## REVISED RESPONSE TO REQUEST FOR ADDITIONAL INFORMATION

### APR1400 Design Certification

Docket No. 52-046

**RAI No.:** 540-8729  
**SRP Section:** 08.02 - Offsite Power System  
**Application Section:** 8.2  
**Date of RAI Issue:** 02/21/2017

**Figure 1 – Typical OPC Detection and Protection Sequence Diagram (with non-Class 1E detection features)**

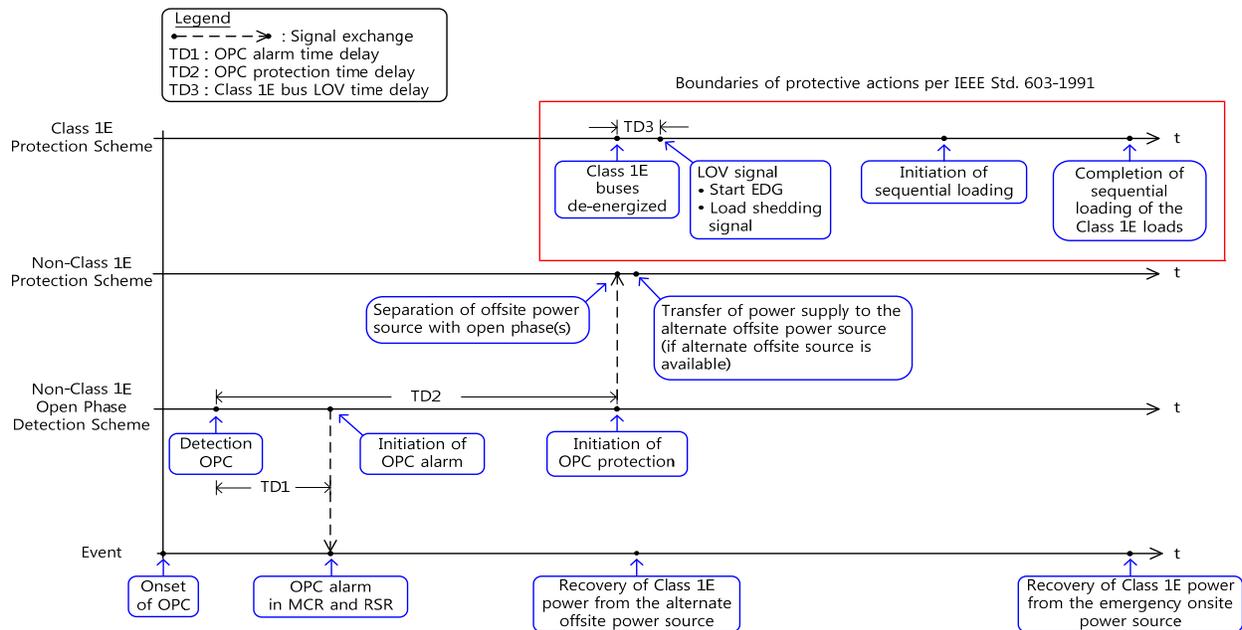
**Item 1.c) Protection scheme should comply with applicable requirements including single failure criteria for ESF systems as specified in 10 CFR Part 50, Appendix A, GDC17, and 10 CFR 50.55a(h)(2) or 10 CFR 50.55a(h)(3), which require compliance with IEEE Std 279-1971 "Criteria for Protection Systems for Nuclear Power Generating Stations" or IEEE Std 603-1991, "Standard Criteria for Safety Systems for Nuclear Power Generating Stations." RG 1.153, "Criteria for Power, Instrumentation, and Control Portions of Safety Systems," provides additional guidance on this topic.**

**If protective features are provided in a non-Class 1E system only, a failure of the non-Class 1E scheme should not preclude the onsite electrical power system from performing its safety function given a single failure in the onsite power system.**

As depicted in Figure 1, the APR1400 overall design features to address an OPC will encompass non-Class 1E and Class 1E systems. Considering the application of IEEE Std. 603-1991, only the Class 1E portion of the design features is subject to the applicable requirements, including the single failure criteria for ESF (Class 1E) systems. Compliance with the requirements for the Class 1E system is addressed in DCD Tier 2, Subsections 8.3.1.1.2 and 8.3.1.2.2. If the COL applicant chooses an OPDP system bounded only for the Class 1E system, the OPDP system as a whole should comply with applicable requirements, including single failure criteria for ESF (Class 1E) systems.

If a failure occurs in the non-Class 1E part of OPC detection and protection features (including a failure of redundant detection features), the failure does not preclude the onsite electric power system from performing its safety function given a single failure in the onsite power system based on the following.

- The worst case single failure in the non-Class 1E portion of the detection and protection features is spurious operation of the detection and protection feature. This condition causes unwanted separation of the offsite power source formerly supplying safety loads. As a result, the Class 1E buses will lose electric power unless the offsite power is transferred to the alternate offsite source. And the loss of voltage condition will automatically initiate operation of the emergency power source for safety loads and maintain the ability of supplying electric power to ESF loads.

- There is no physical or functional interface or interdependency between a failure in the non-Class 1E features and protective actions of the Class 1E features. No single point vulnerability exists between the non-Class 1E and Class 1E features owing to proper physical separation in accordance with IEEE Std. 384-1992 as endorsed by RGs 1.32 and 1.75.

- The Class 1E protection scheme is redundant and independent, so the safety function of the Class 1E system is not compromised given a single failure in the onsite power system.

- Therefore, a failure in the non-Class 1E portion of the OPC detection and protection features does not preclude the onsite electric power system from performing its safety function given a single failure in the onsite power system.
